SECTION 009113 – ADDENDUM TWO

- A. Project Name: 22034.03 Meridian High School Baseball/Softball Rebid
- B. Owner: Meridian Public School District, 1019 25th Avenue, Meridian, MS 38391
- C. Architect: Dale | Bailey, an Association, One Jackson Place, Suite 250, 188 East Capitol Street, Jackson, MS 39201-2100
- D. Architect Project Number: 22034.03
- E. Date of Addendum Two: 18 August 2023

C-501

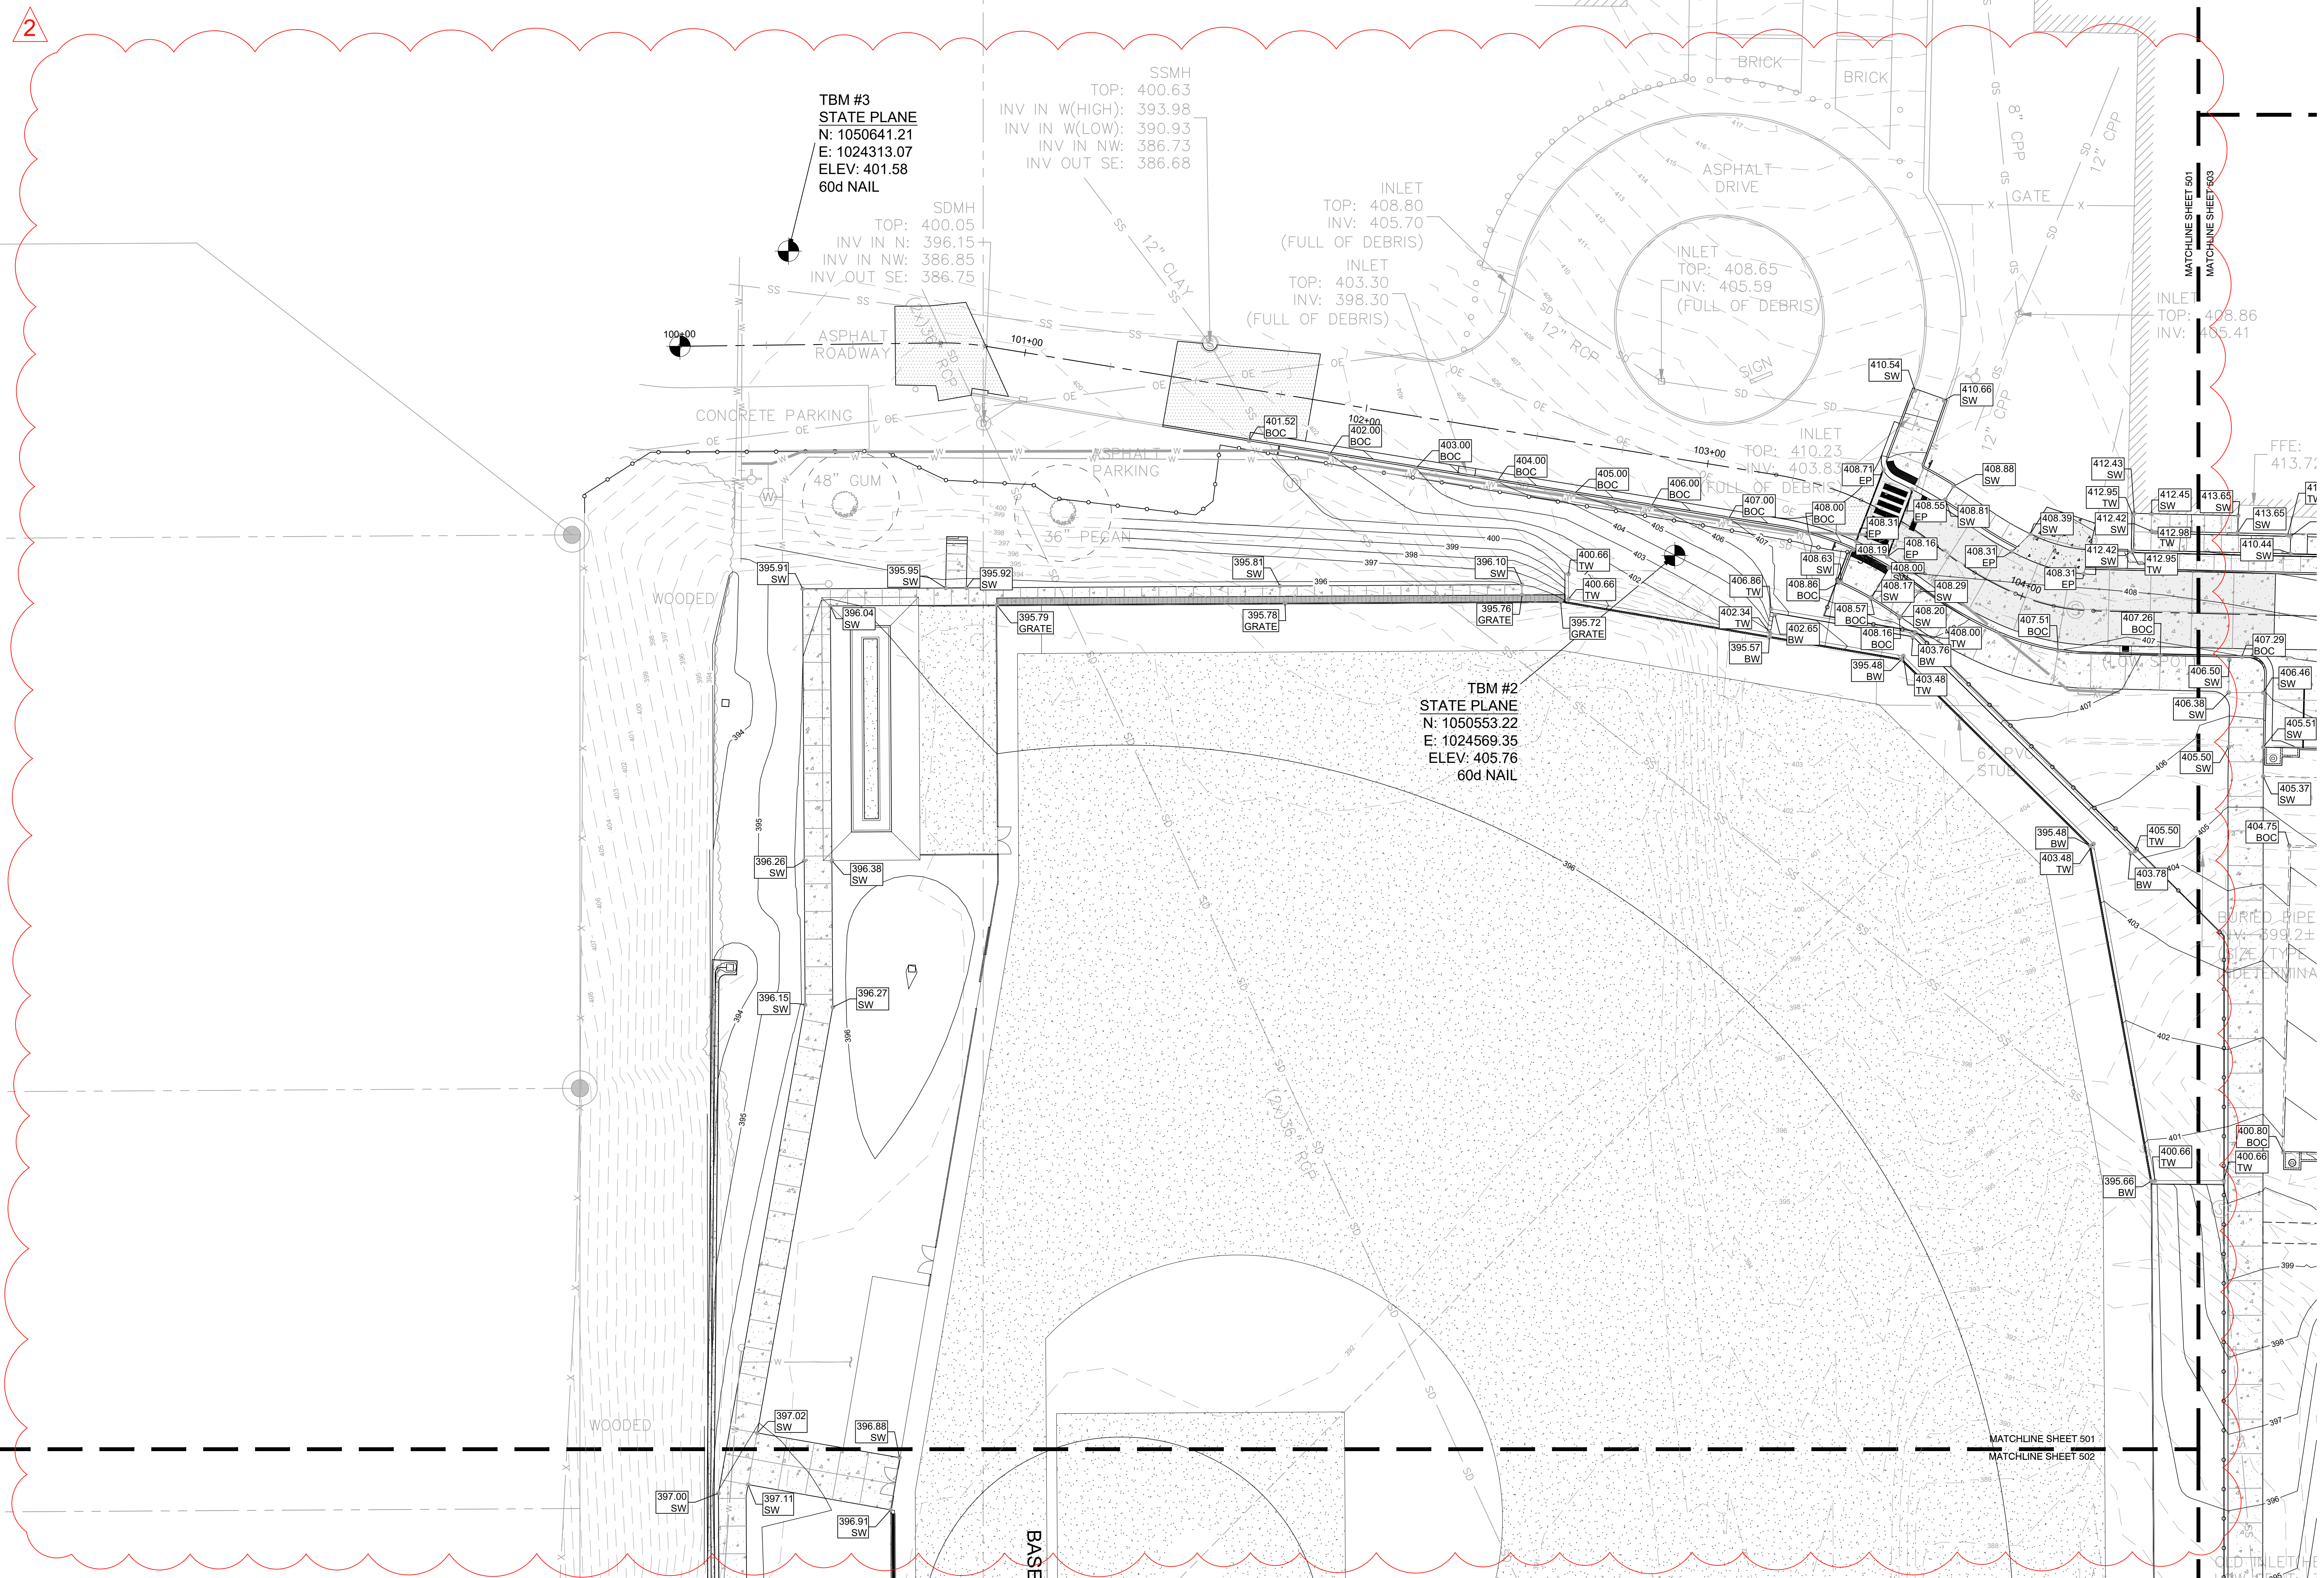
- D. Civil Sheet C-501 – Grading Plan (Reissued). Delete this sheet in its entirety and replace it with the attached. Adjusted contours and added point labels.

C-503

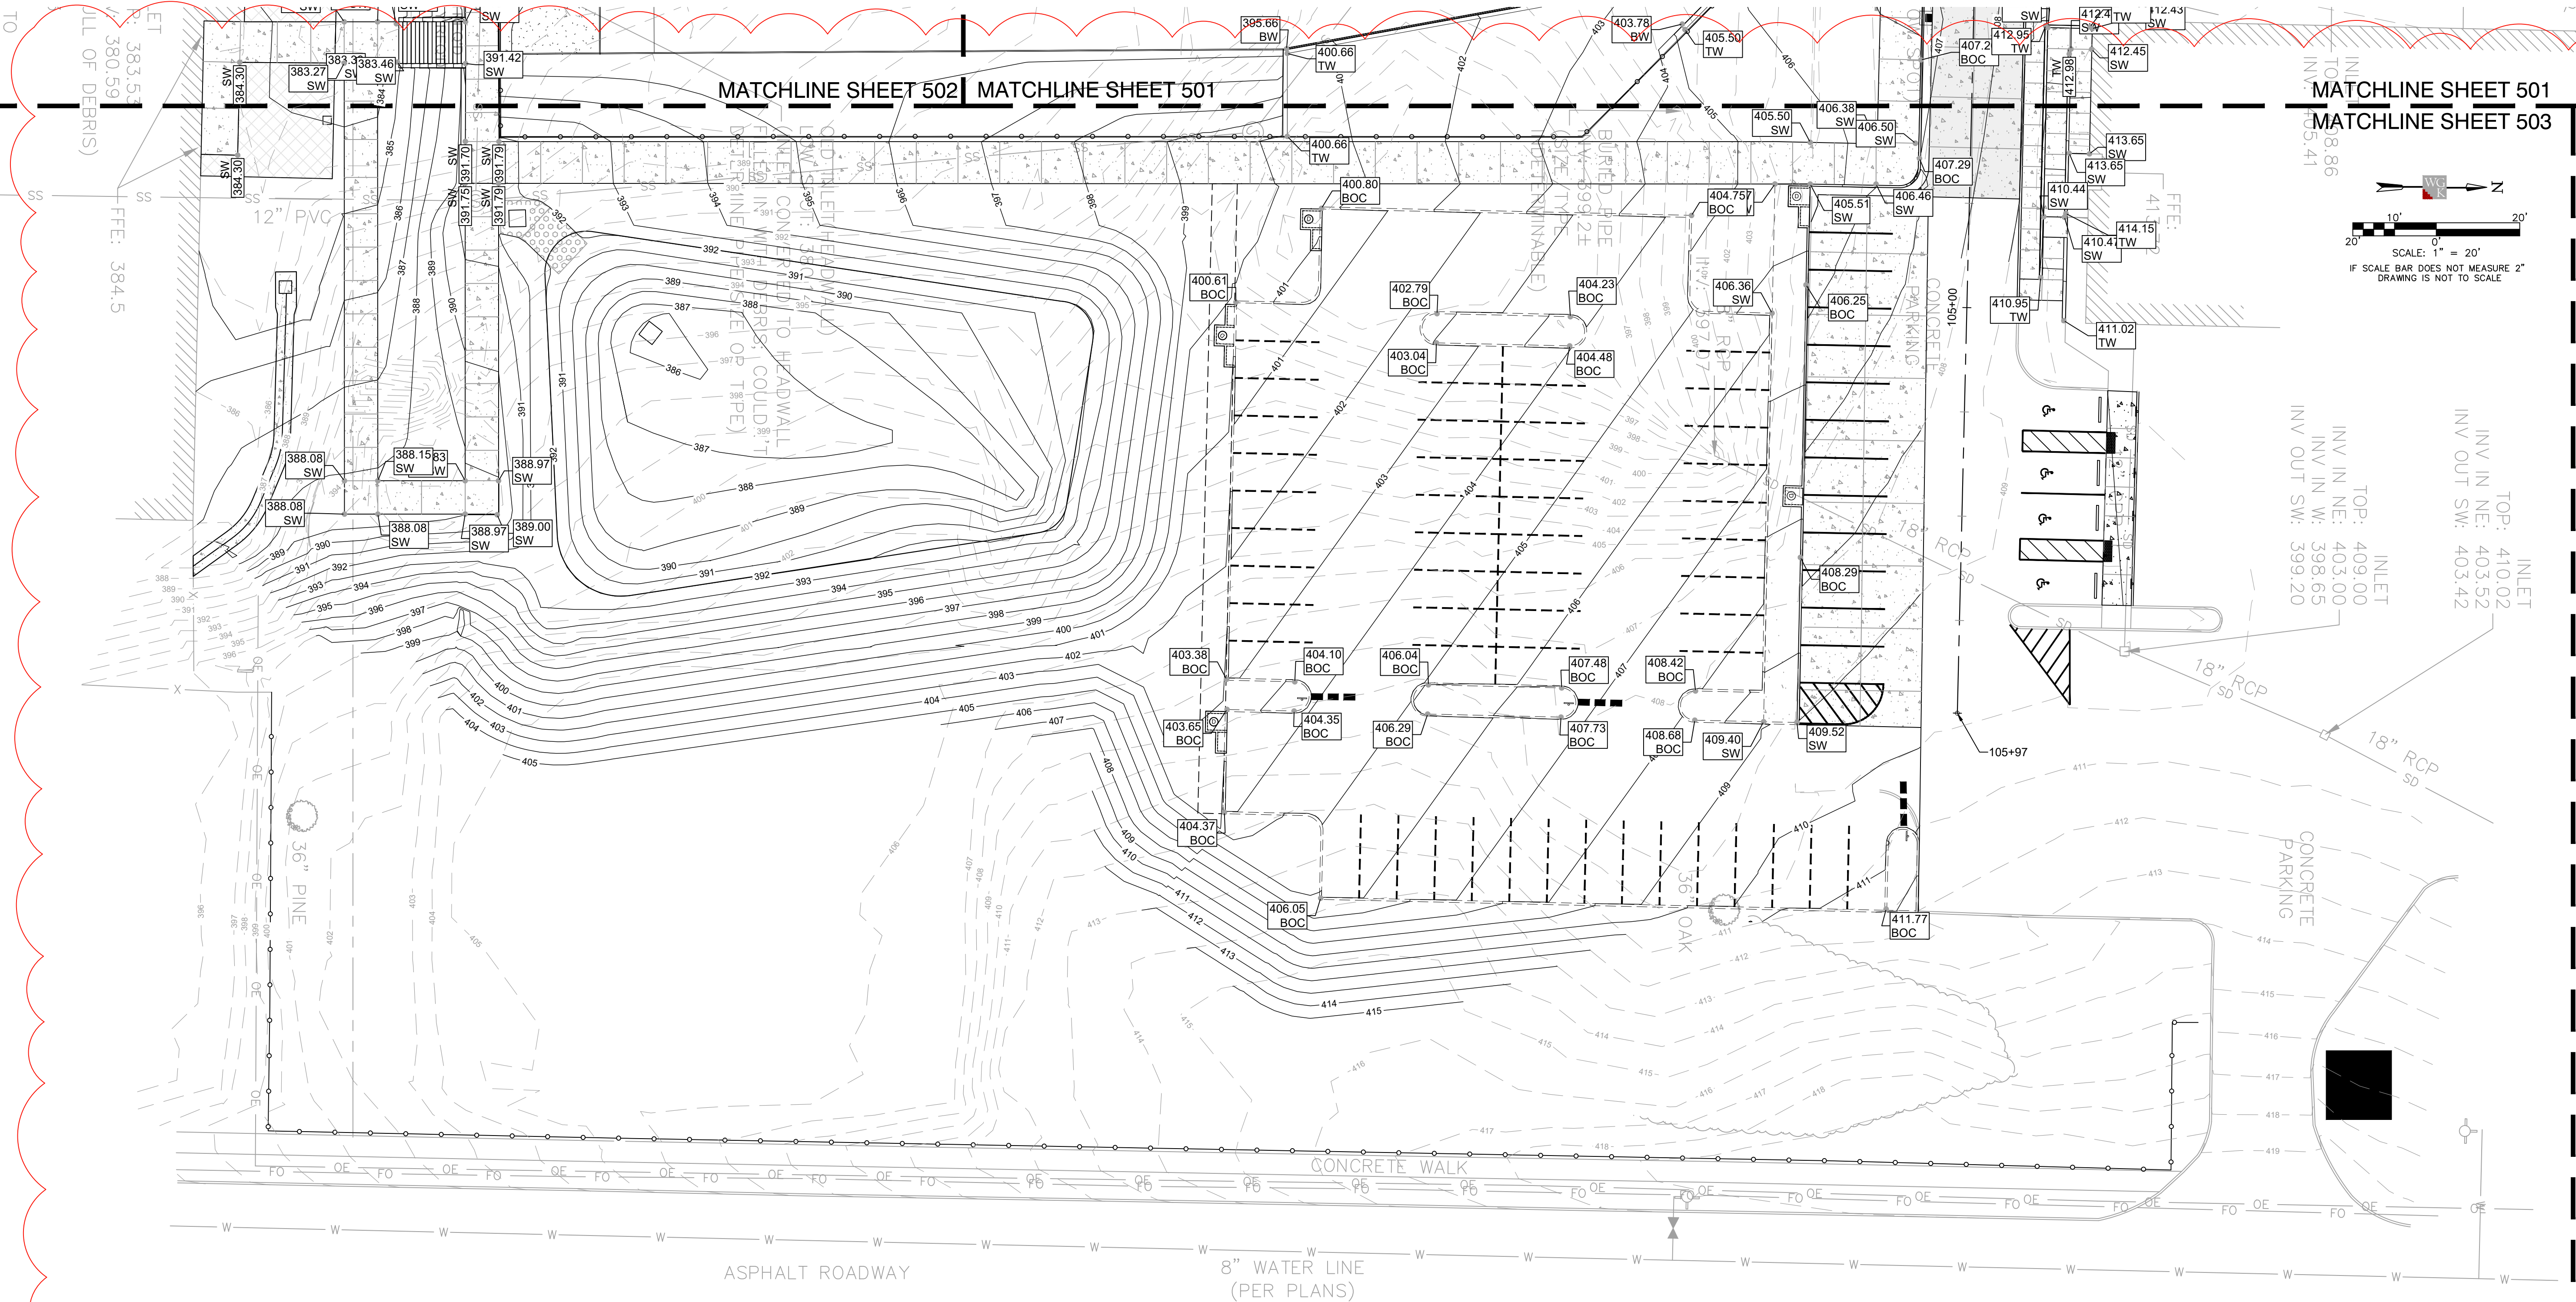
- F. Civil Sheet C-503 – Grading Plan (Reissued). Delete this sheet in its entirety and replace it with the attached. Adjusted contours and added point labels.

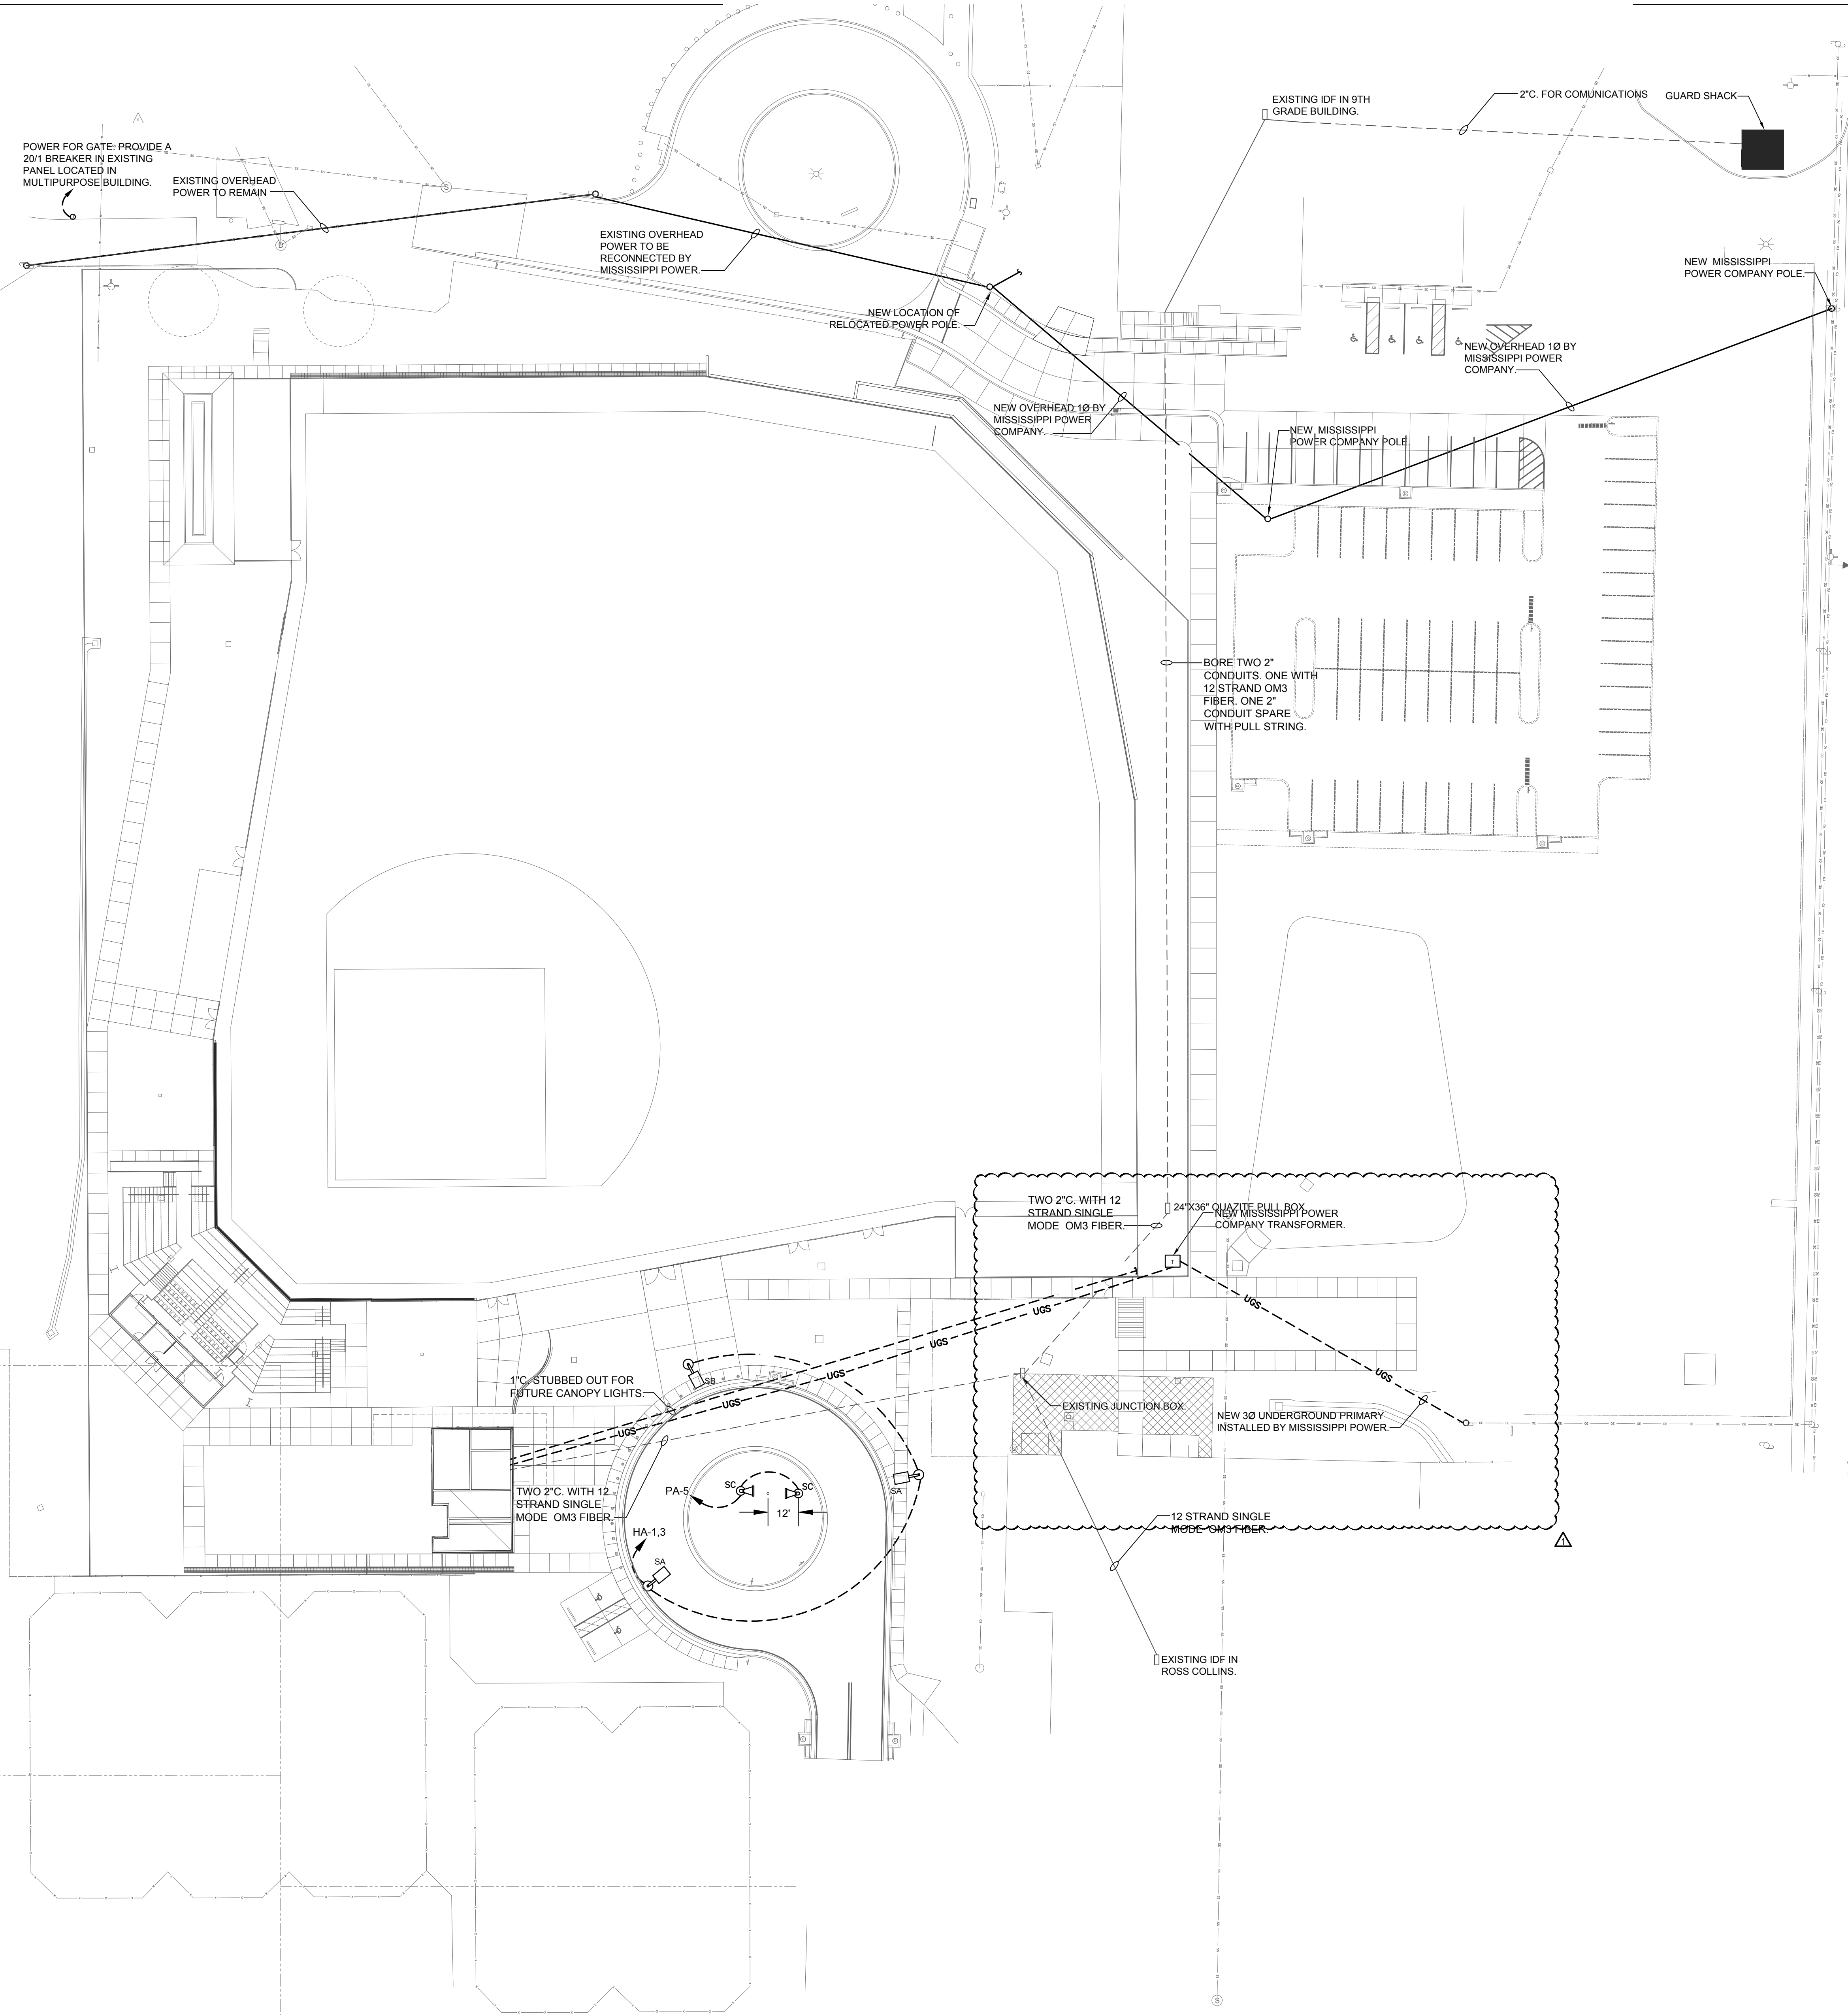
- G. Electrical Sheet E-003 – Meridian High Baseball Field Renovation Site Plan (Reissued). Delete this sheet in its entirety and replace it with the attached. Relocated transformer.
